Application Number: 10/037,548
Filing Date: January 04, 2002
Appellant(s): KORENEVSKY, LEV

**SUPPLEMENTAL
EXAMINER'S ANSWER**

Art Unit: 1744

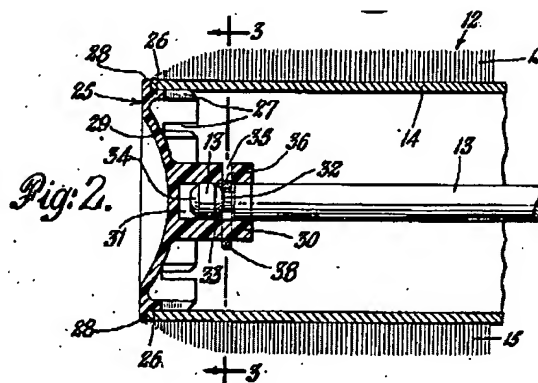
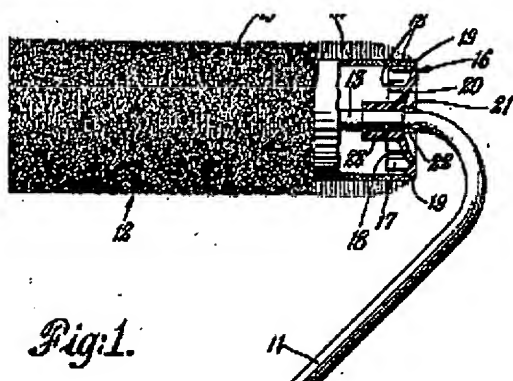
With regards to claims 1-3 and 6 as being rejected by Thackara, the appellant argues that the two end units are *independently mounted on the shaft (axle, spindle) while in my design the end units are attached to each other via a mating connection*. The examiner would like to point out figures 1 and 2 of Thackara.

Figure 1 shows one end of the paint applicator and figure 2 shows the other end. The appellant is correct in stating that the end units of Thackara are independently mounted on the shaft, however the two end units are in mating connection with each other. The term "mating connection" does not limit the connection to being directly mated together. A mating connection could refer to

any elements that are connected together by some means, whether it is directly or indirectly.

Thackara teaches end units that are indirectly connected.

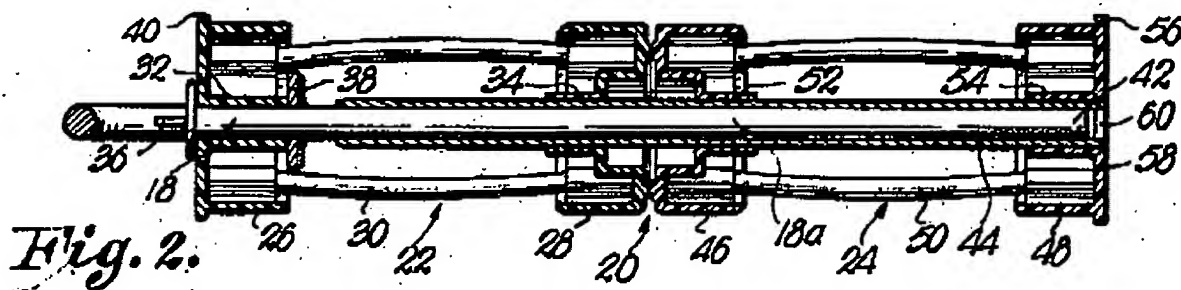
With regard to claims 1-4, 6 and 8 as being rejected by Newman, the appellant argues that the two end units are *independently mounted on the shaft (axle, spindle) while in my design the end units are attached to each other via a mating connection*. The examiner would like to point to figure 2 of Newman.

Figure 2 shows both ends of the paint applicator connected together by the shaft (18). The appellant is correct in stating that the end units of Newman are independently mounted on the shaft, however the two end units are in mating connection with each other. The term “mating connection” does not limit the connection to being directly mated together. A mating connection could refer to any elements that are connected together by some means, whether it is directly or indirectly. Newman teaches end units that are indirectly connected.
